ADDENDUM NO. 4

Wayne High School Campus Improvements

Fort Wayne Community Schools (FWCS)

November 17, 2025

2. Plan Sheet C2.1 – Site Dimensional Plan – Zone A

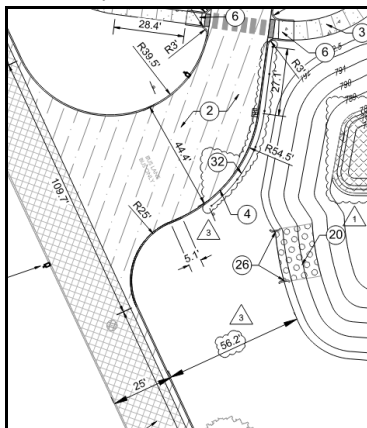
ADDED: Traffic barrier between bus lane and detention basin 1 on plan and detail legend.

3. Plan Sheet C3.2 – Site Grading Plan – Zone B

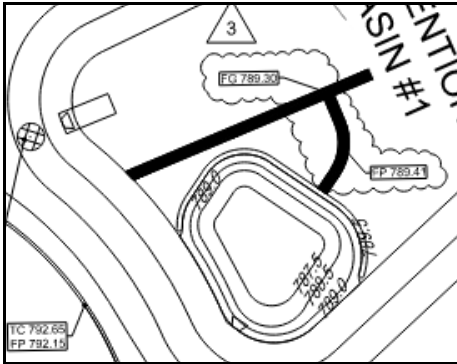
ADDED: Spot grades for detention basin along infiltration trench and rock channel.

4. Plan Sheet C4.1 – Site Utility Plan – Zone A

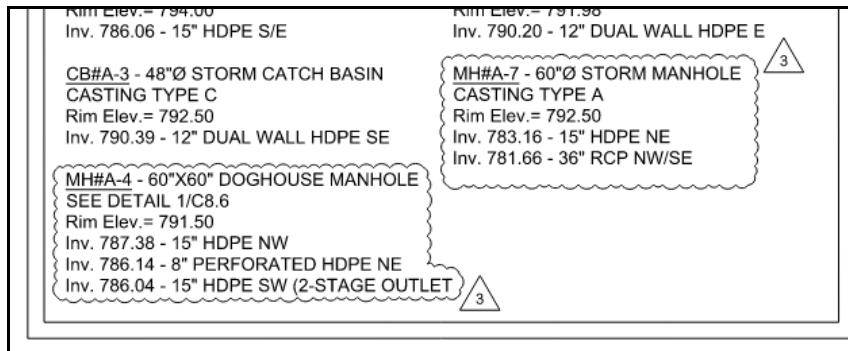
REVISED: Pipe size for perforated pipe in detention basin.

ADDED: Callout to existing water quality unit.

ADDED: MH#A-7 to plans and revised MH#A-4 structure placement and pipe inverts.

6. Plan Sheet L1.1 – Site Landscape Plan – Zone A

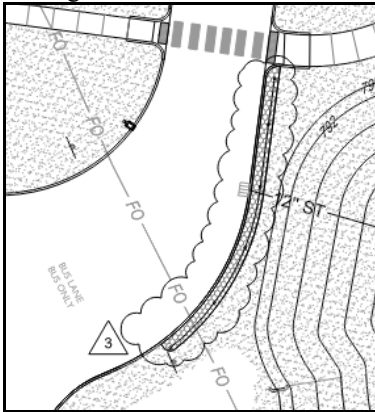
ADDED: River rock mulch along the traffic barrier fence between bus lane and detention basin 1 on plan and legend.

7. Plan Sheet C8.3 – Site Details Sheet I

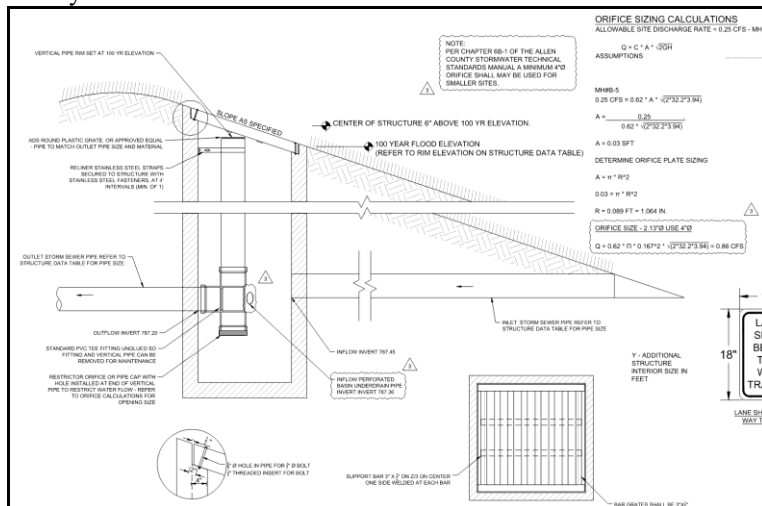
REVISED: Detail 1/C8.3 orifice note to match Allen County standards

REVISED: Detail title to include “Basin 2” for identification.

REVISED: Perforated pipe crossing callout to “Inflow Perforated Basin Underdrain” per Allen County Surveyor’s comments.

8. Plan Sheet C8.6 – Site Detail Sheet VI

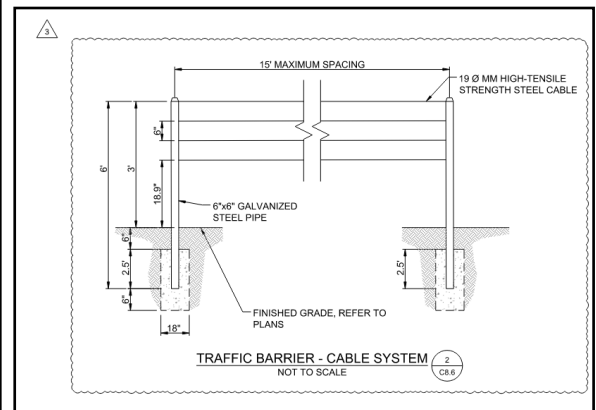
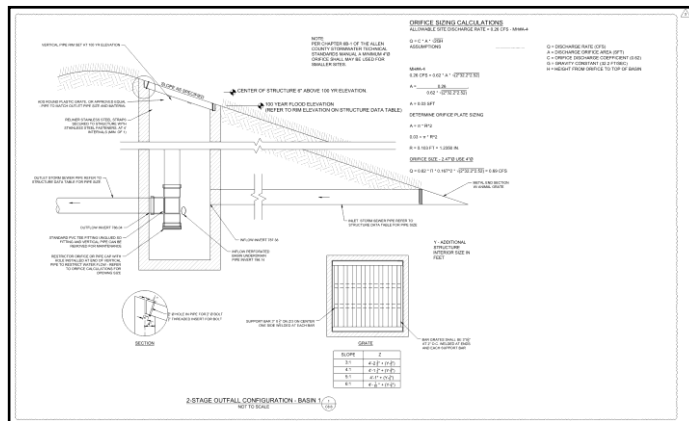
REVISED: Detail 1/C8.6 to match Deatil 1/C8.1

ADDED: Detail 2/C8.6 Traffic Barrier – Cable System.

9. Plan Sheet E211F – Site Electrical Plan – Zone F

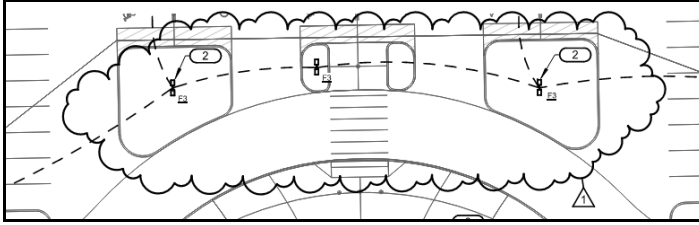
REVISED: Lighting near ticket booth plaza

10. Plan Sheet E300 – Electrical Enlarged Plans

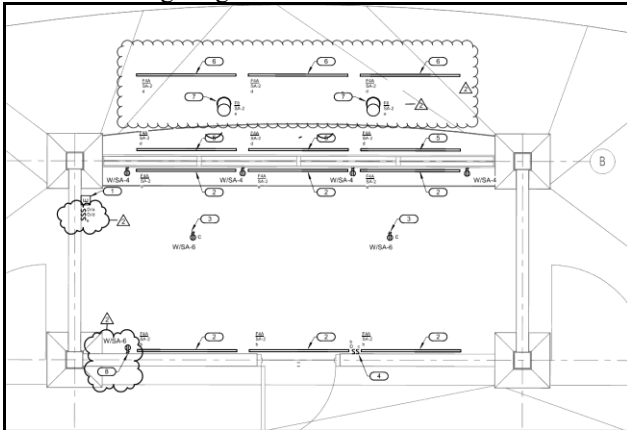
REVISED: Lighting at the ticket booth

5. Plan Sheet C4.2 – Site Utility Plan – Zone B

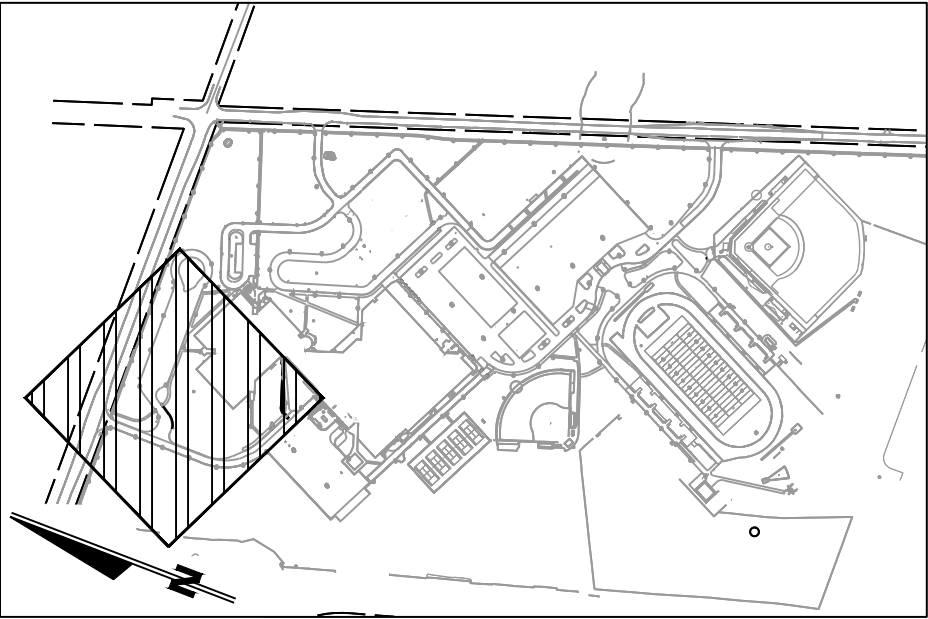
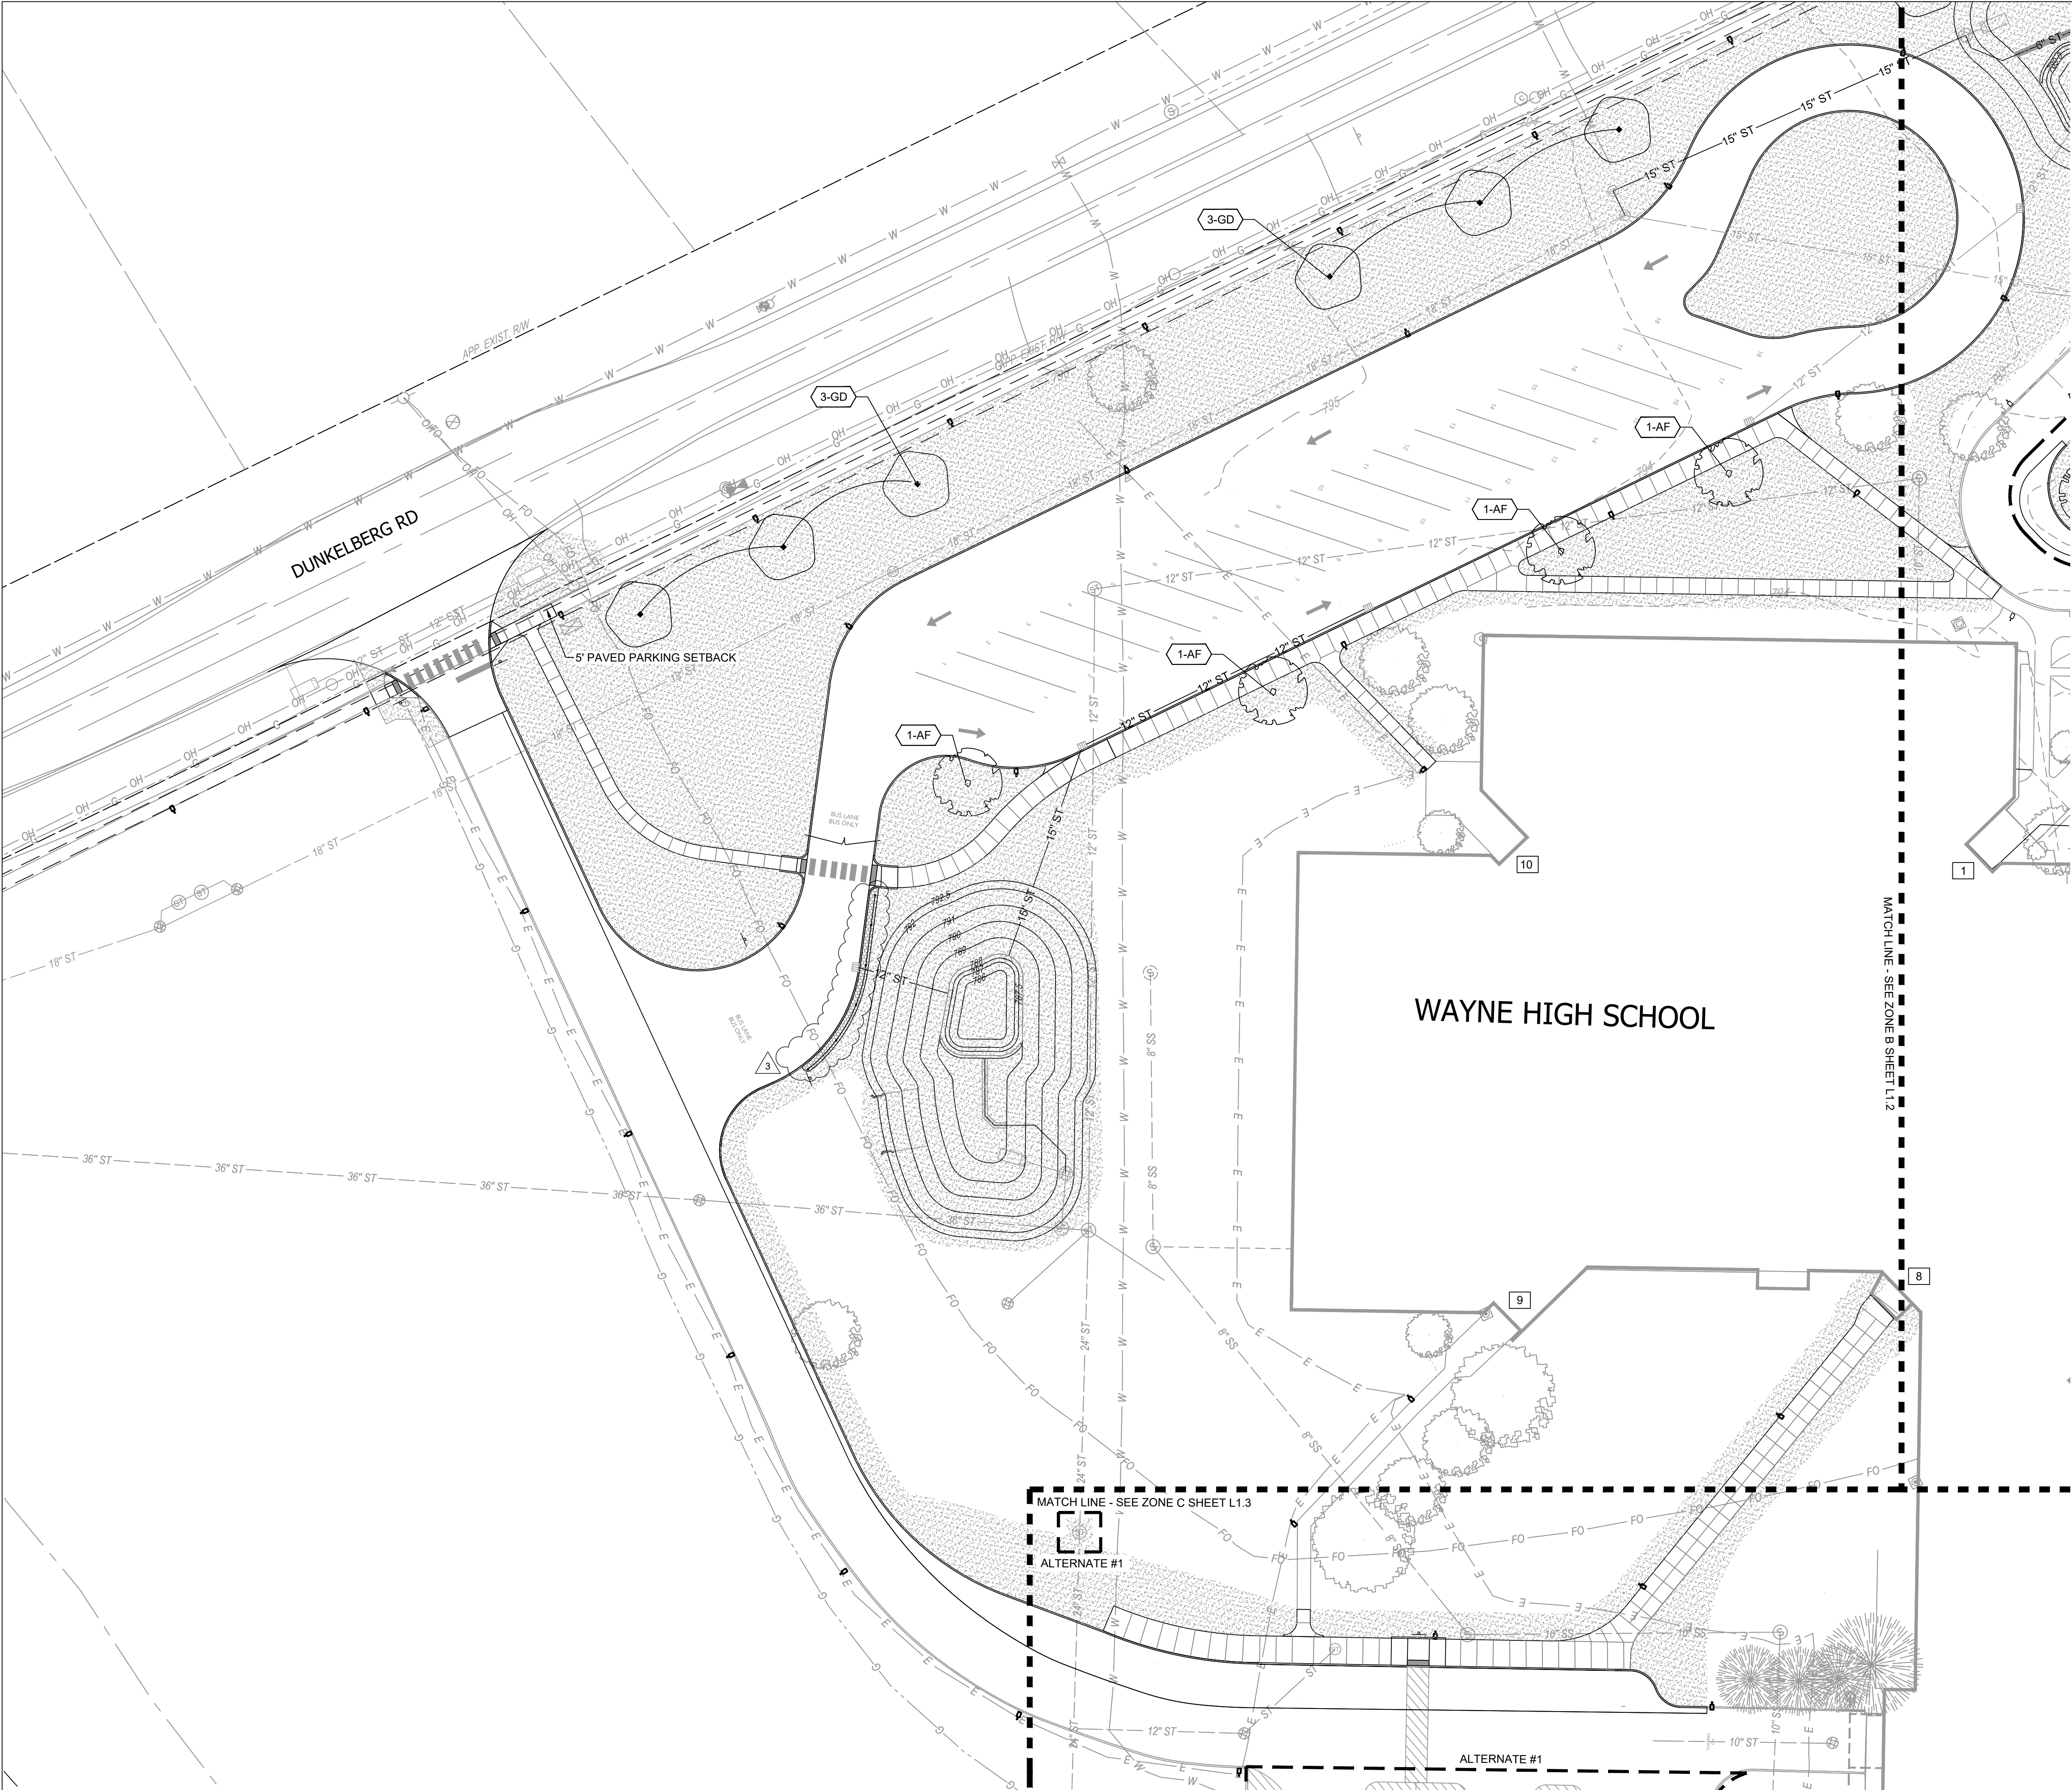
REVISED: MH#B-5 size from 48"X48" to 60"X60".
